NEW STYLE REPLACEMENT

OLD STYLE - COMPARABLE

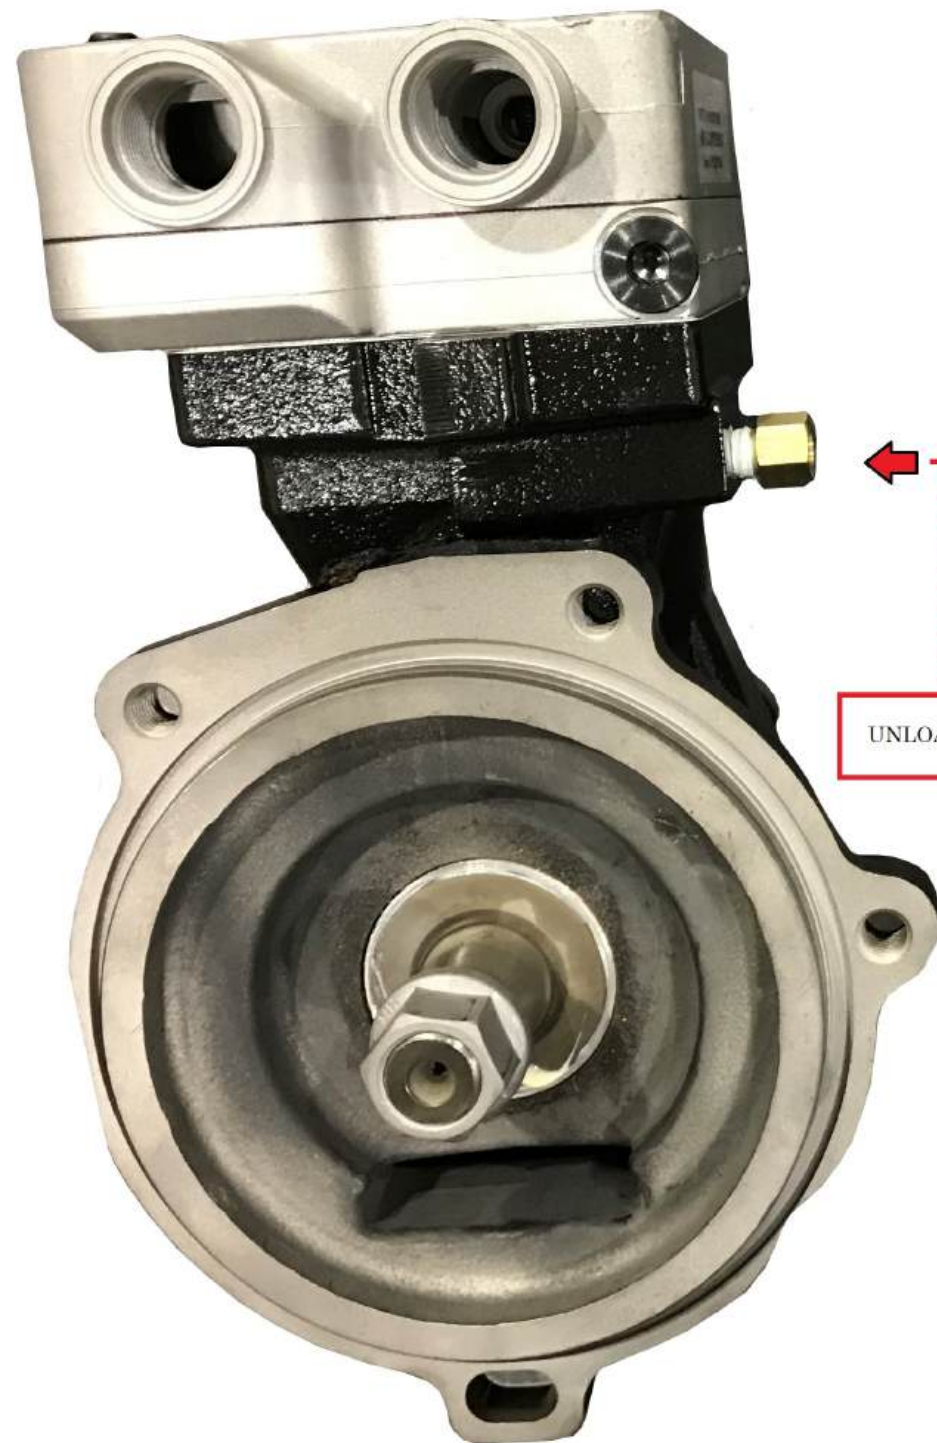
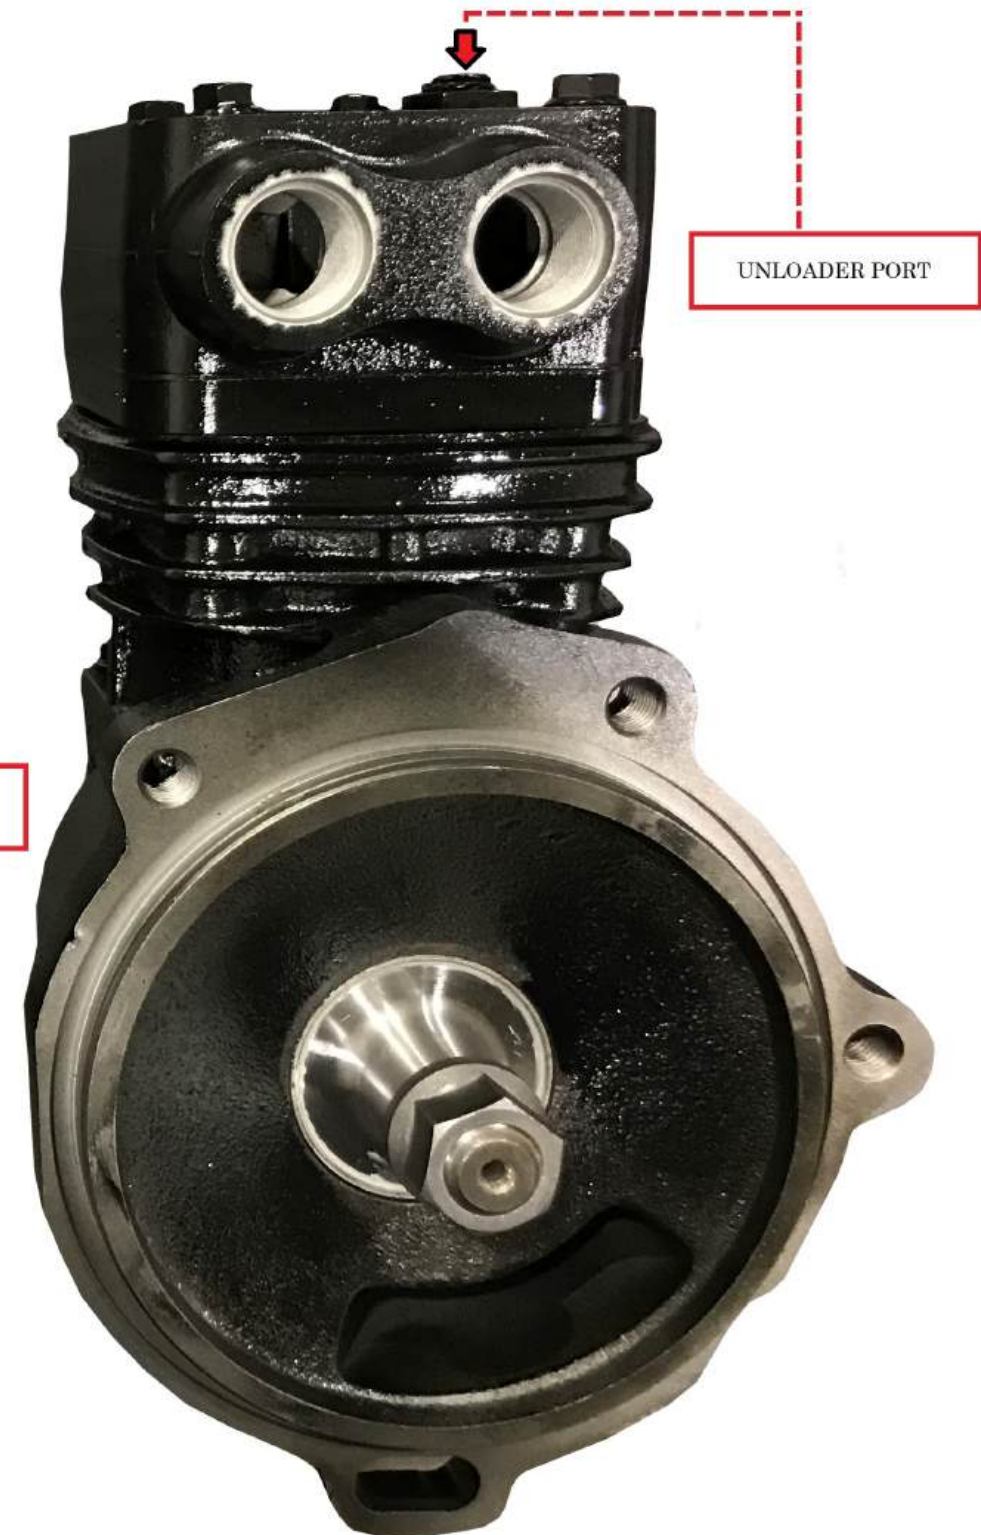
* THE ONLY DIFFERENCE BETWEEN THESE (2x)
AIR COMPRESSORS IS THE UNLOADER LOCATION AND
FITTING. GOVERNOR AIR LINE WILL NEED TO BE MOVED.*
